To: T10 SAS Protocol Working Group

From: Brian Day [and George Penokie](#)

Subject: ~~SAS-2.1~~ [SPL](#): 08-249 Link Layer Power Management

This proposal is a complement to 08-015 [and 08-206](#). This proposal focusses on link layer changes to support lower power modes.

Figure 120 — SL (link layer for SAS logical phys) state machines (part 23)

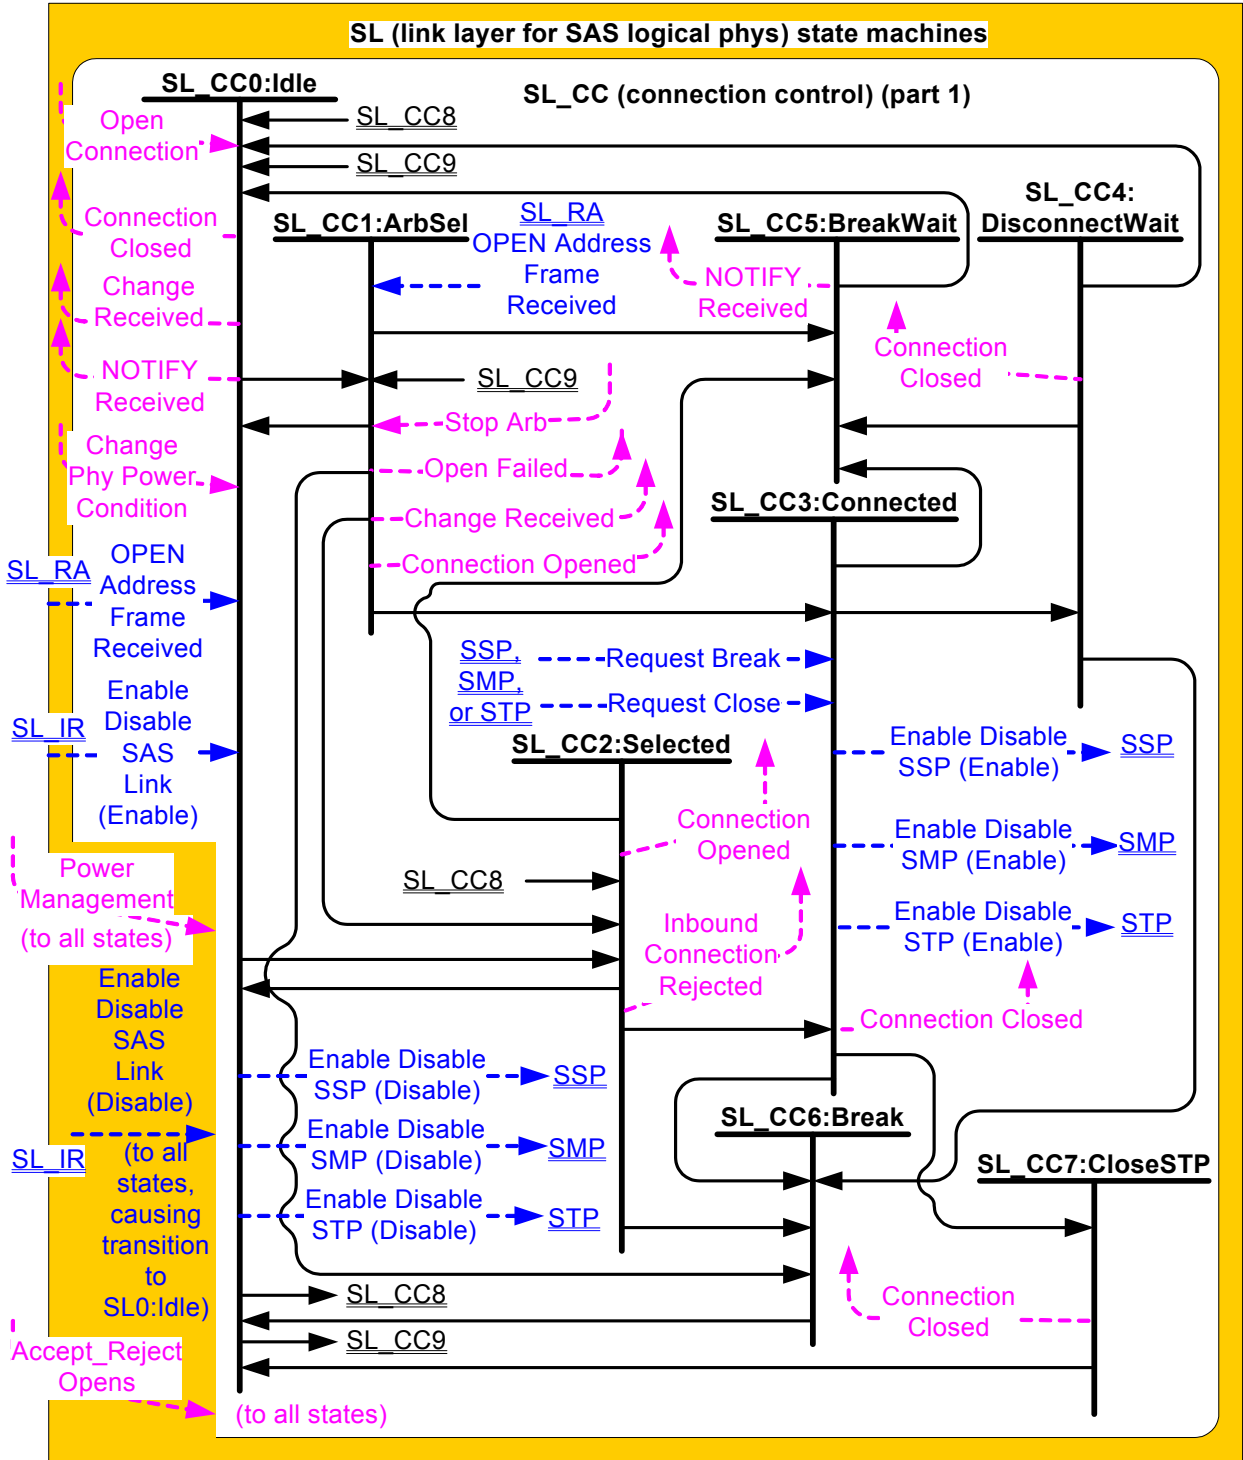
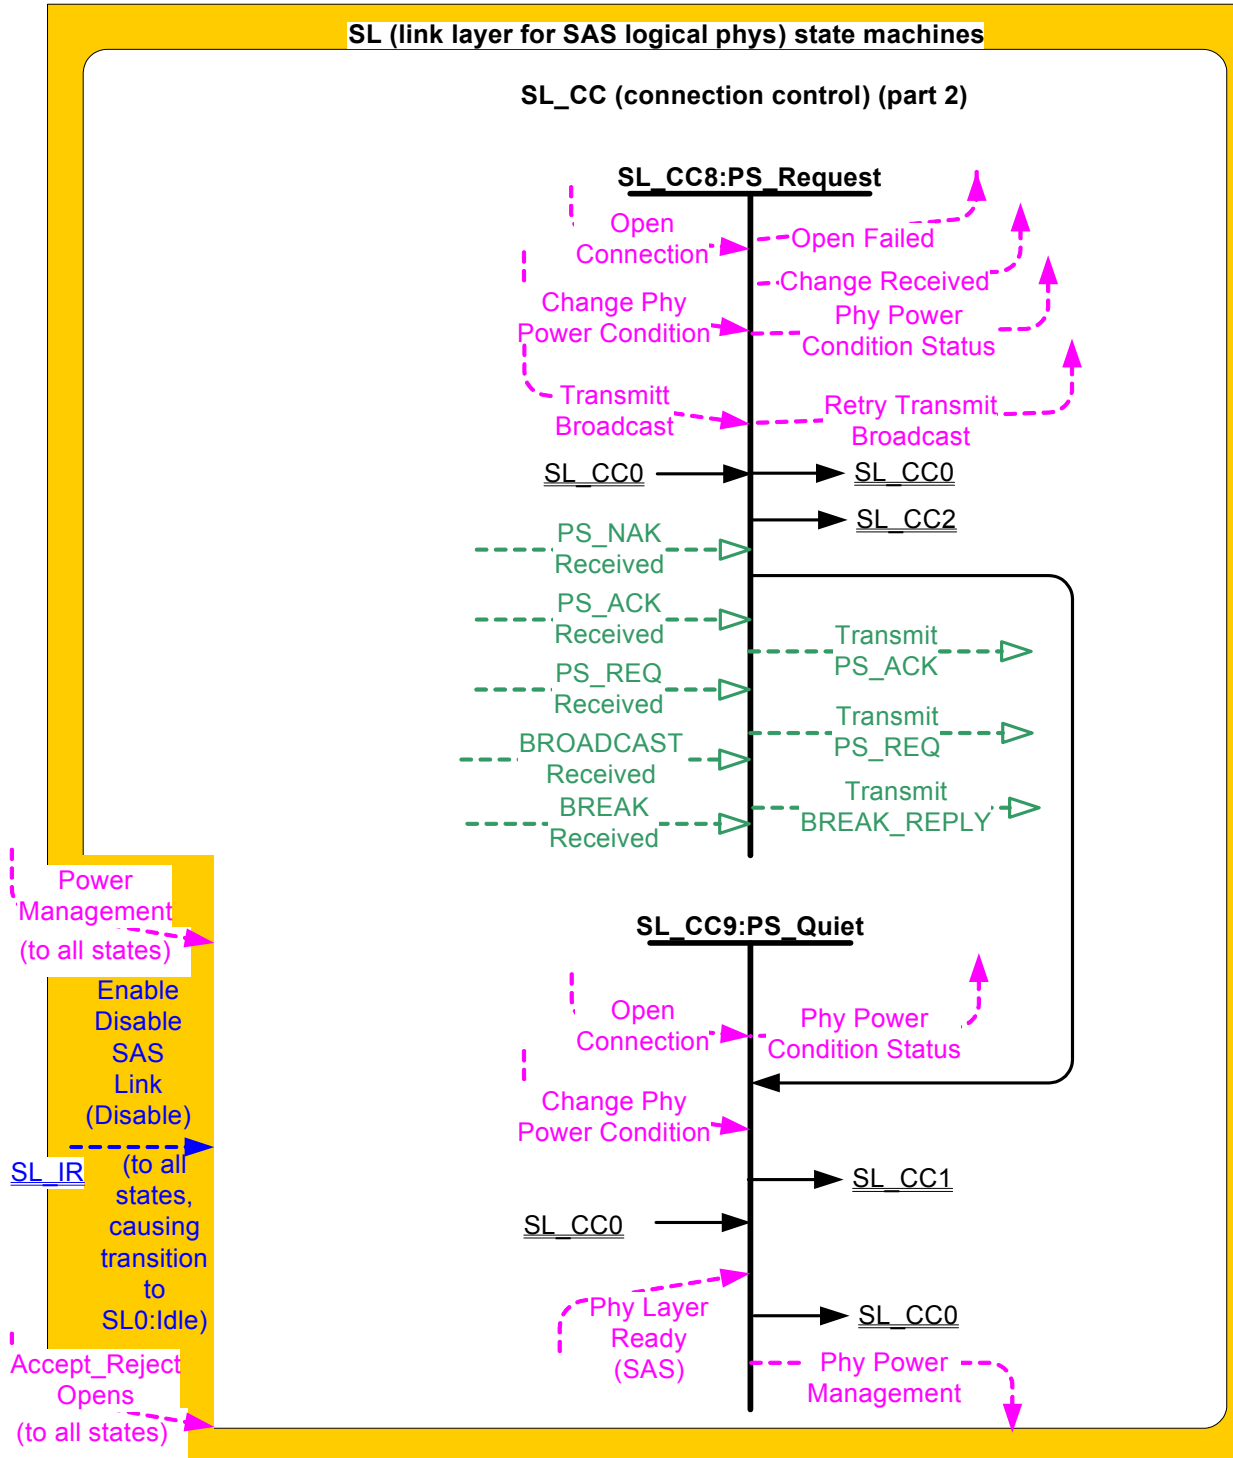
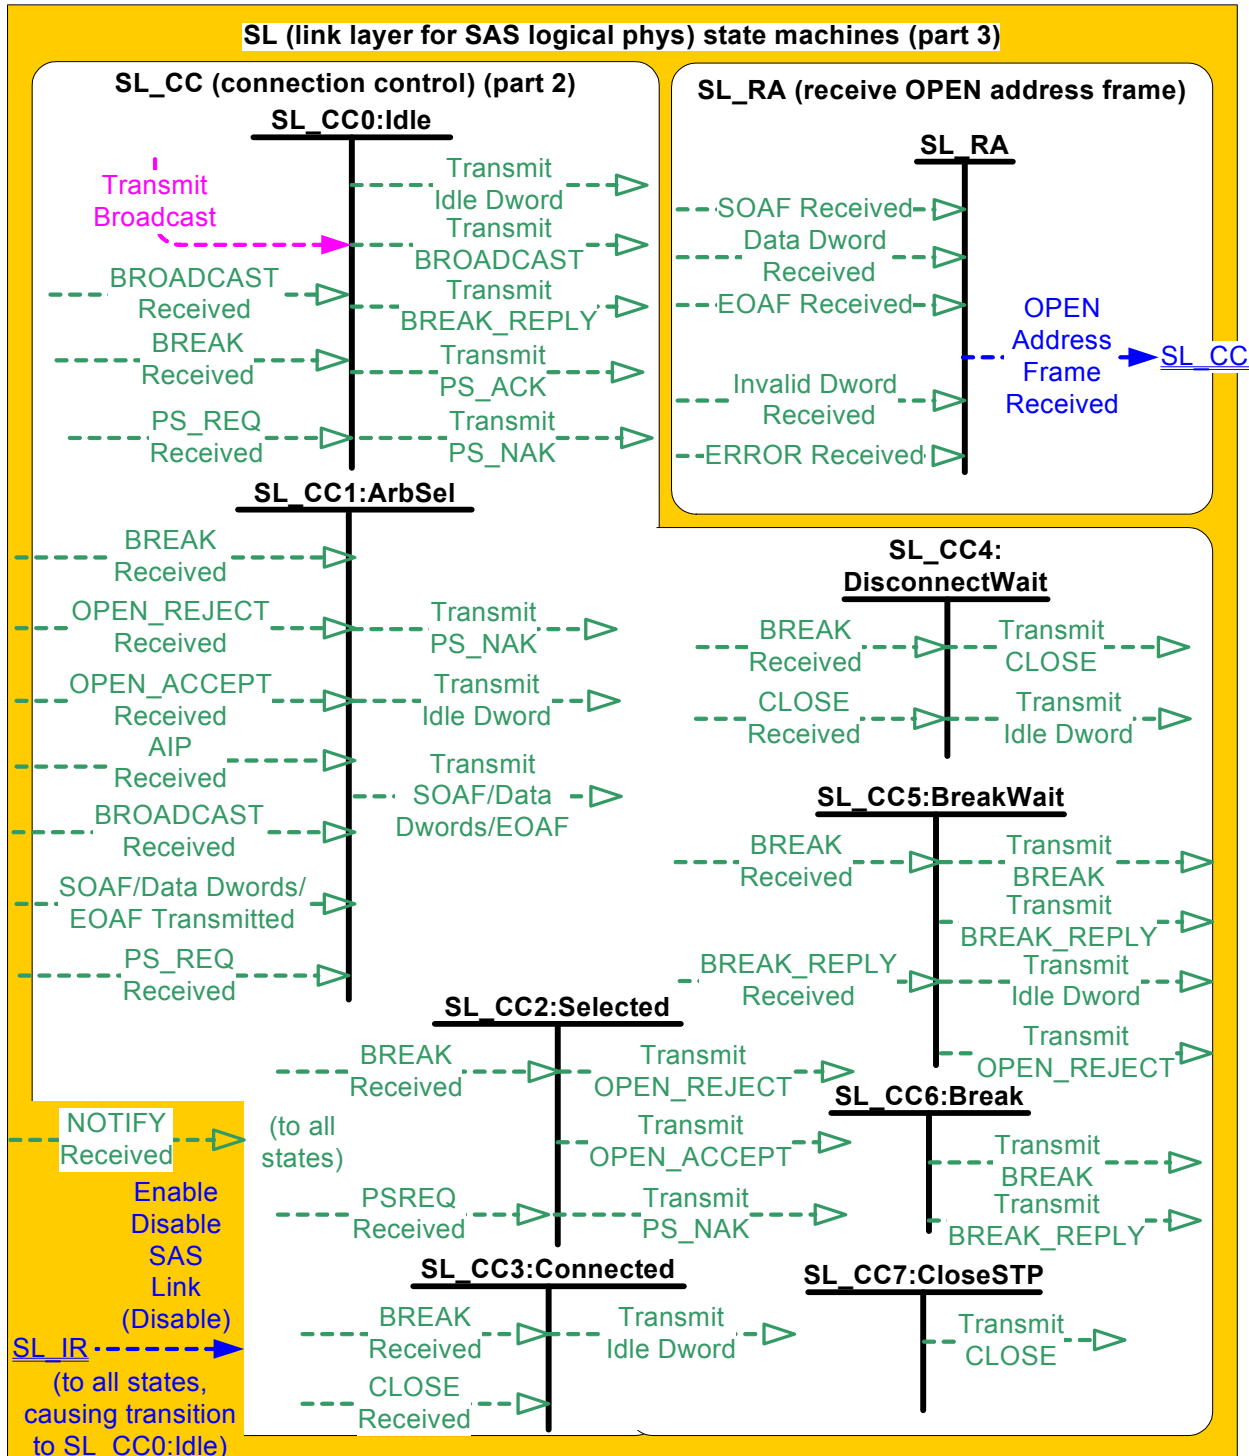
Figure 118 [and figure 119](#) show the SL state machines.

Figure 120 shows the messages sent to the SL transmitter and received from the SL receiver.

Figure 121 — XL (link layer for expander logical phys) state machine (part 1)

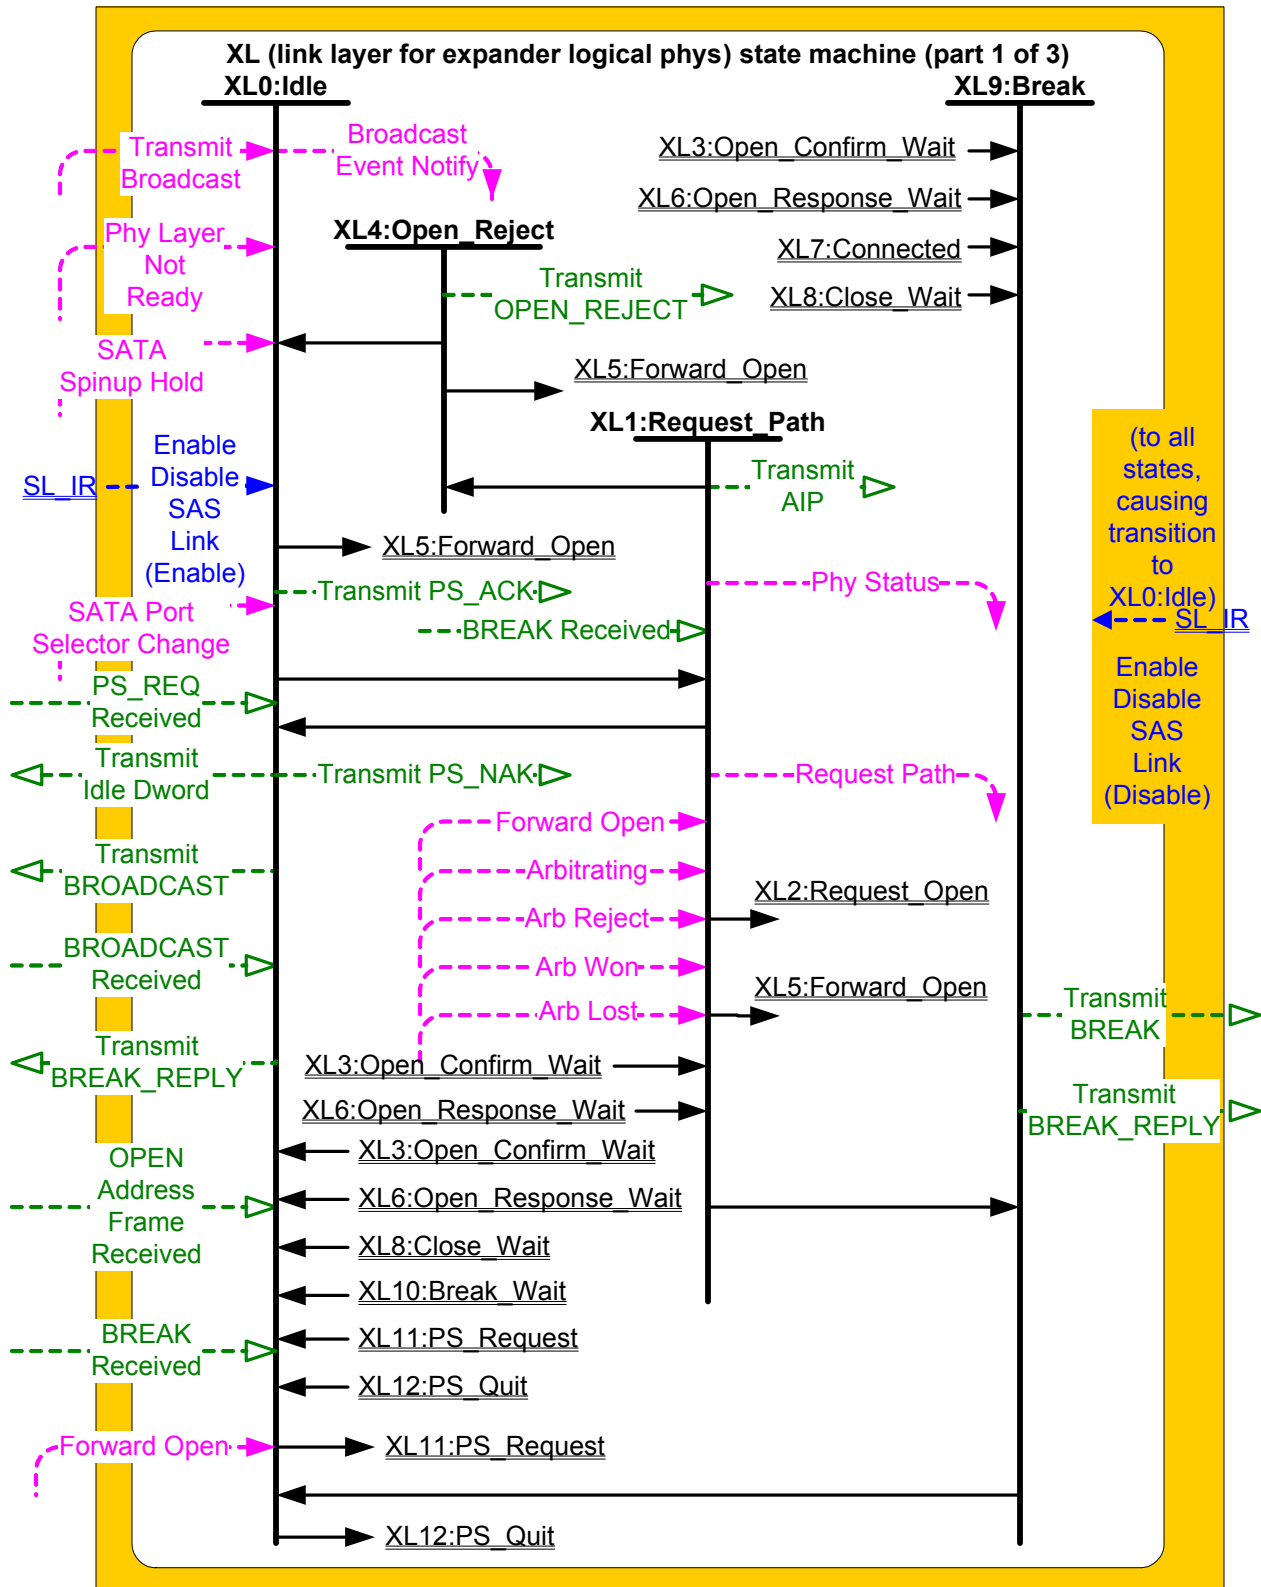
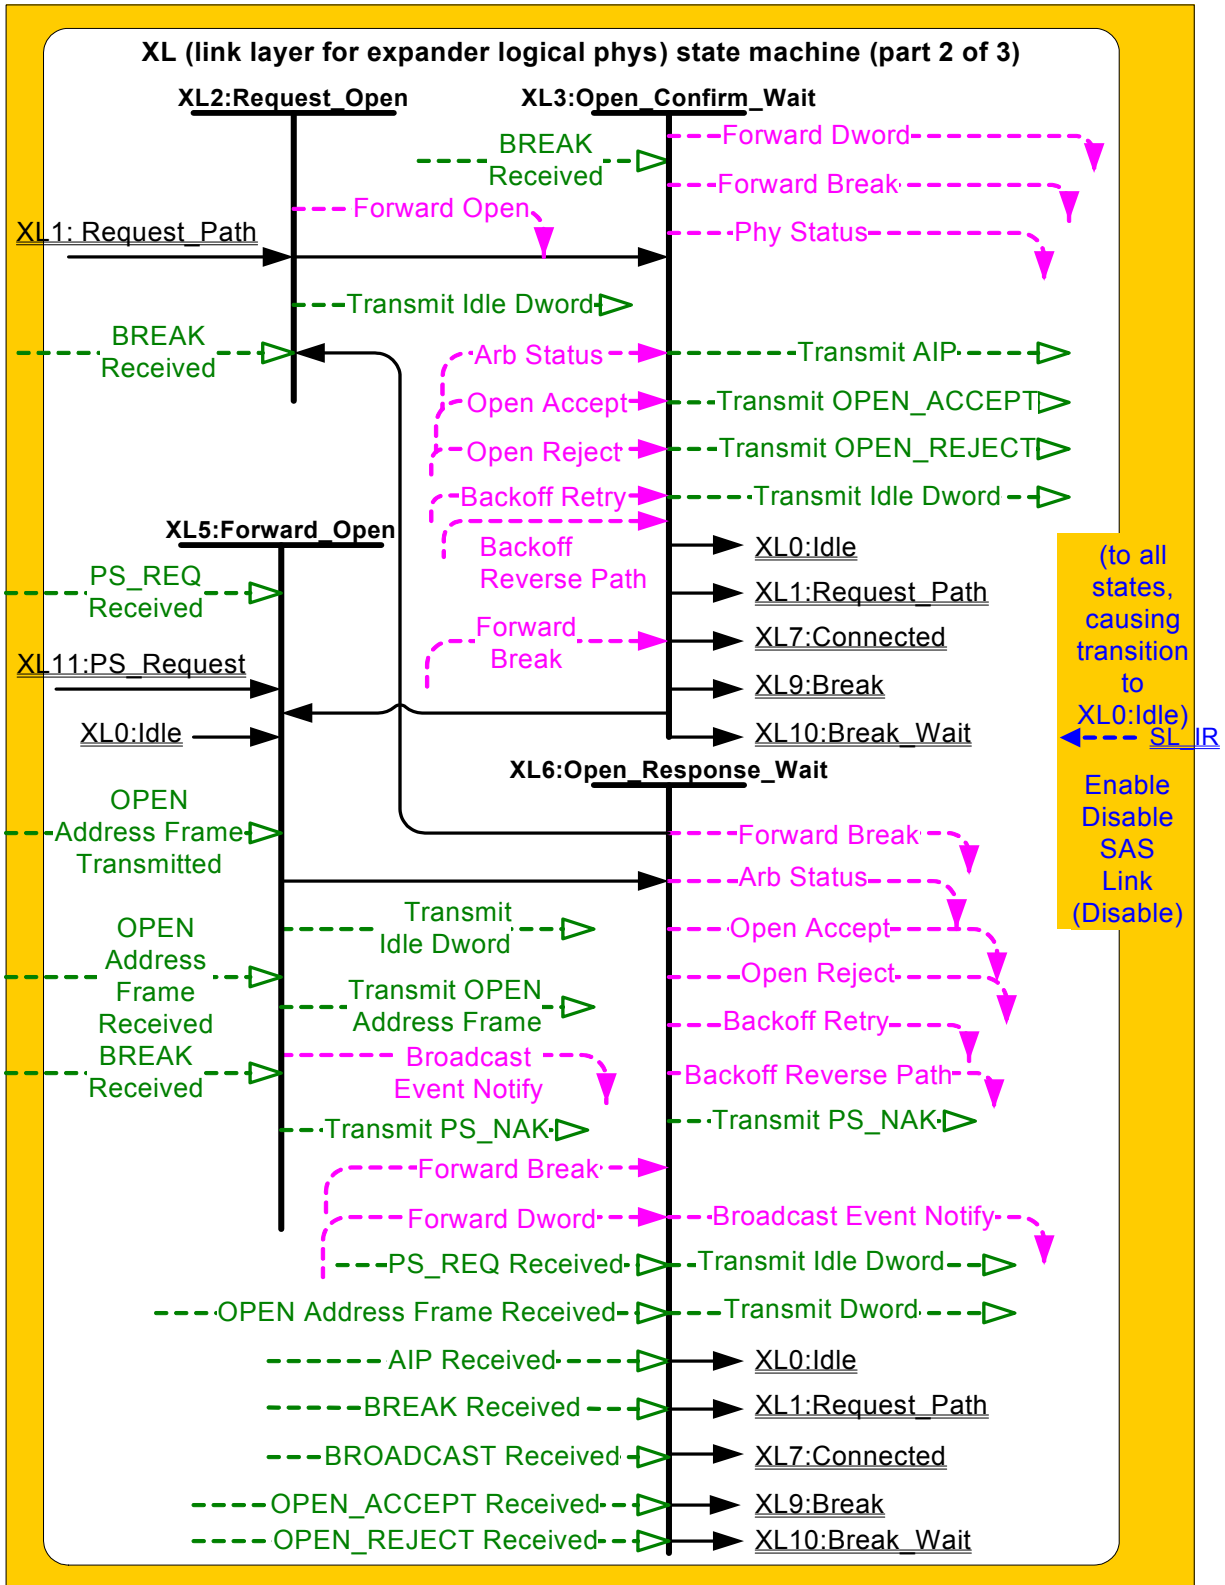
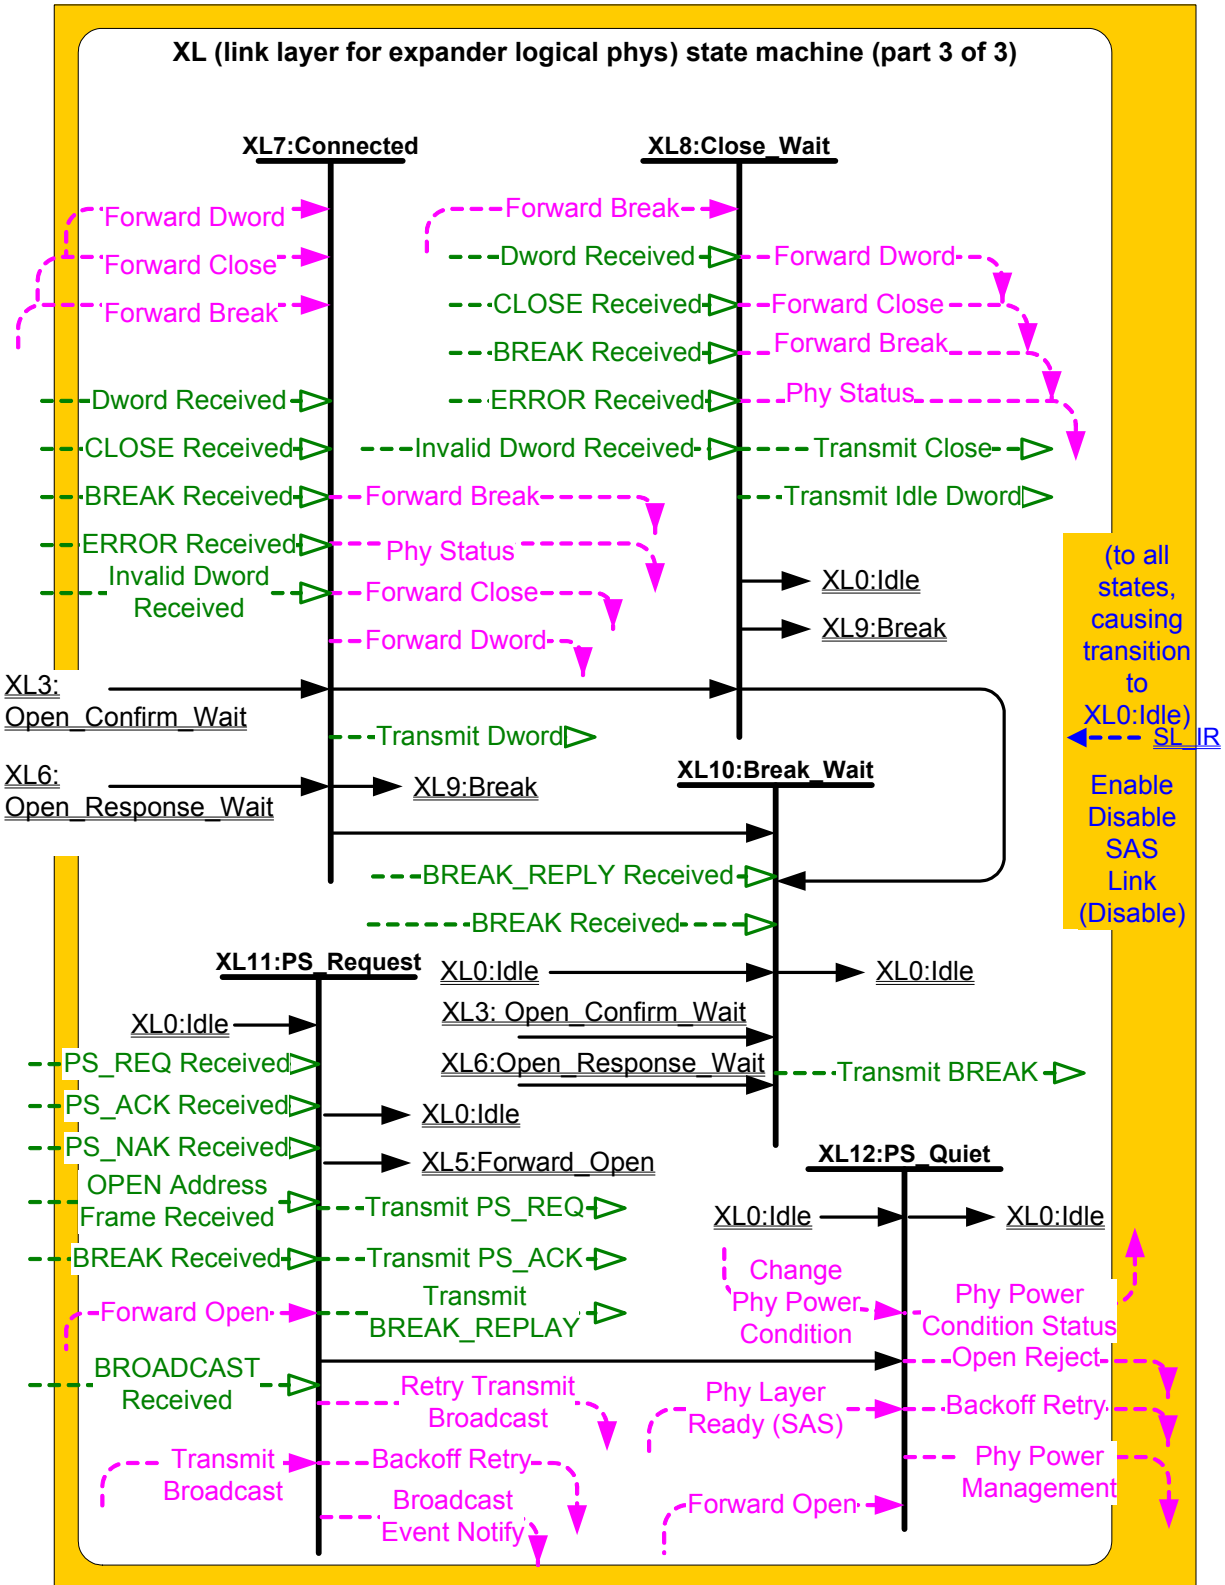
Figure 121 shows several states in the XL state machine.

Figure 122 shows additional states in the XL state machine.

Figure 123 shows additional states in the XL state machine.
